U.S. Department of the Interior
BUREAU OF LAND MANAGEMENT

Well Name: MICHENER LS

Subsequent Report

Type of Action: Plug and Abandonment

Current Schematic - Version 3

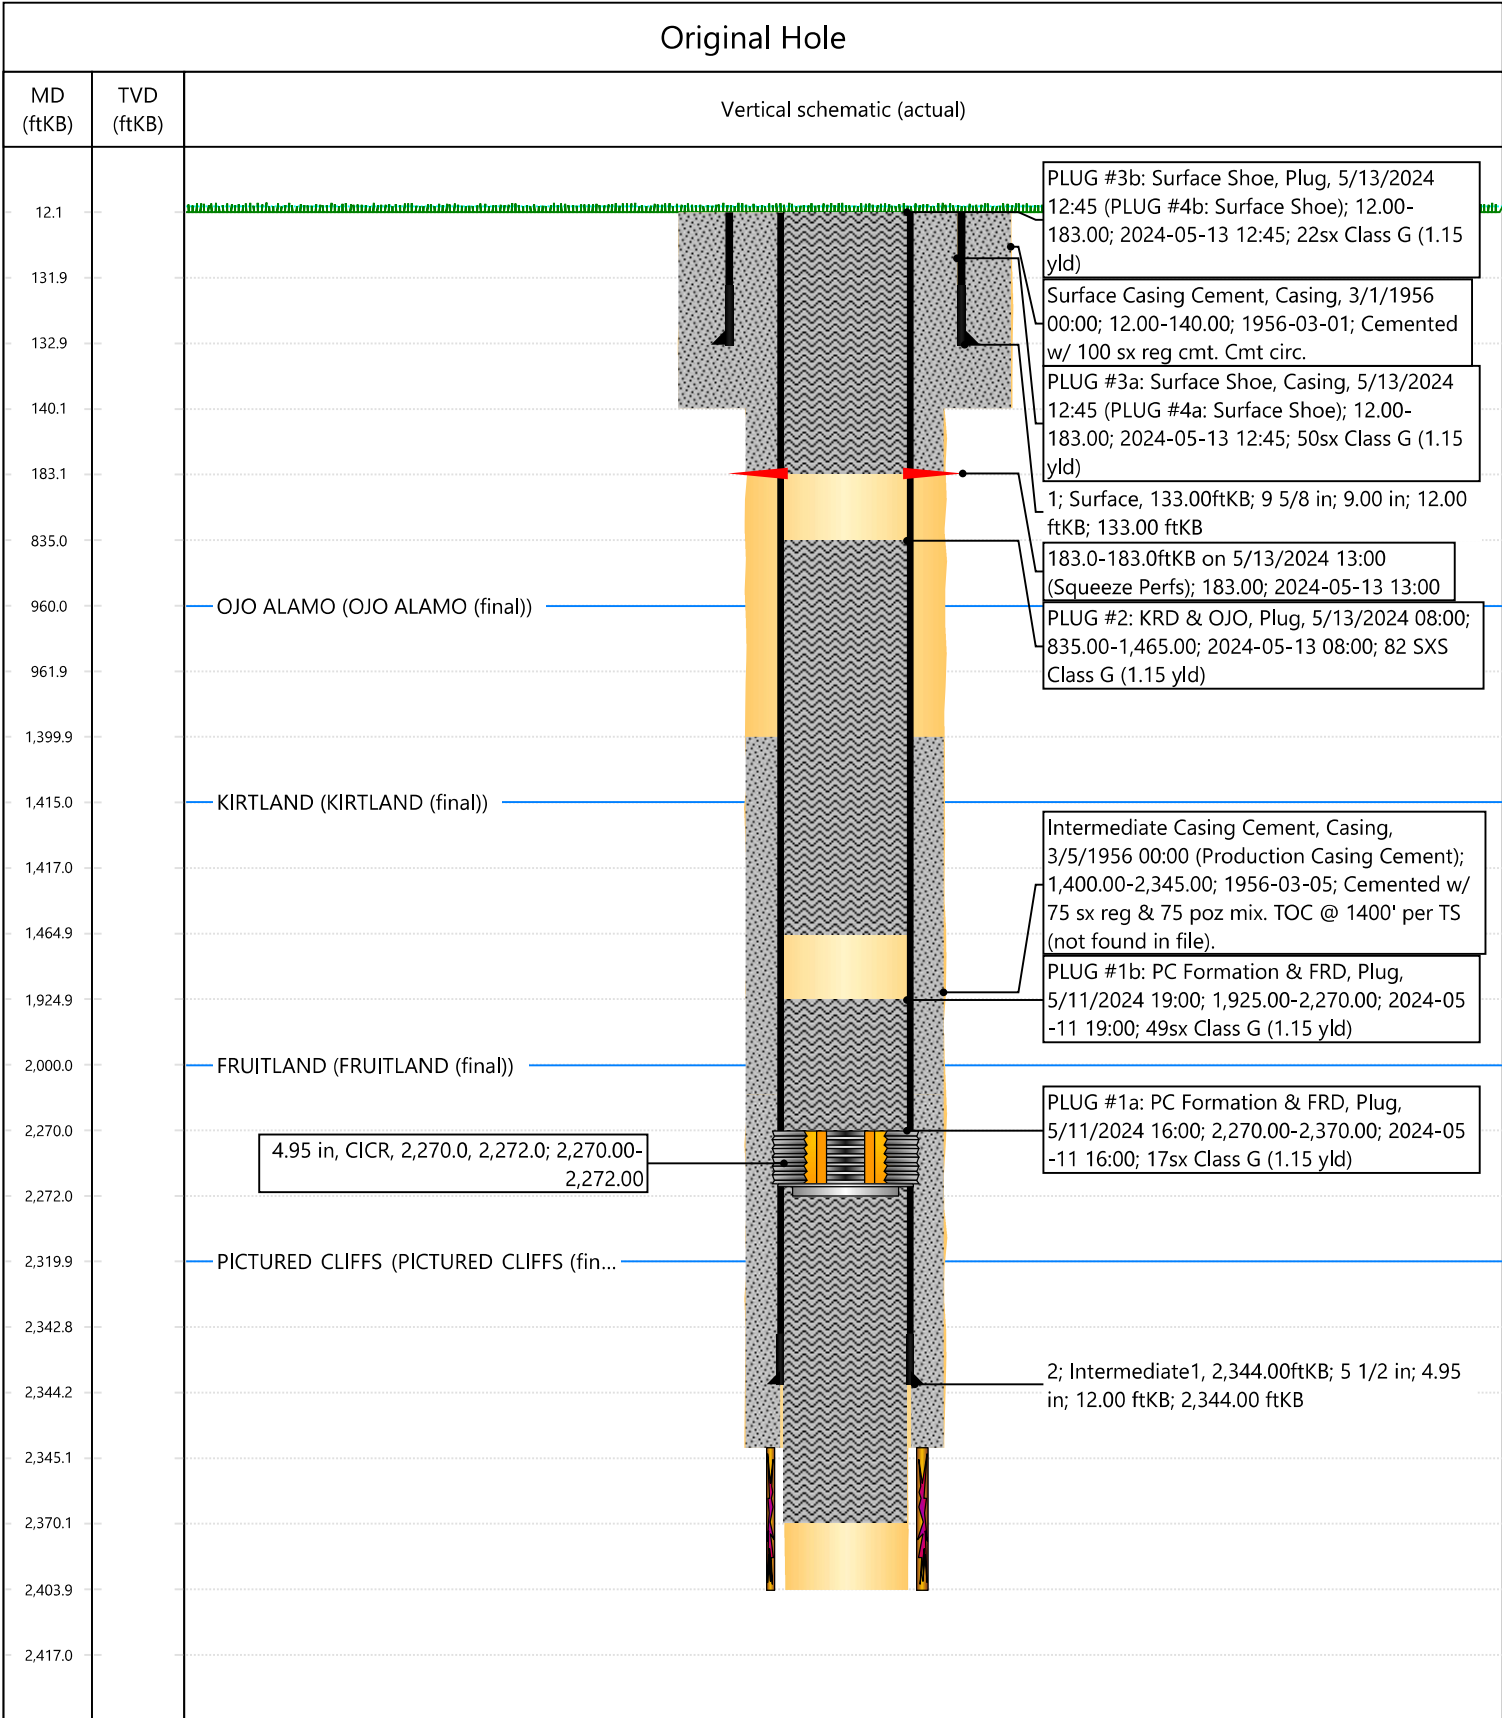
Created By	Condition	Condition Date
mkuehling	schematic doesn't show cement on outside at ojo - log showed cement - well plugged 5/13/2024	5/16/2024
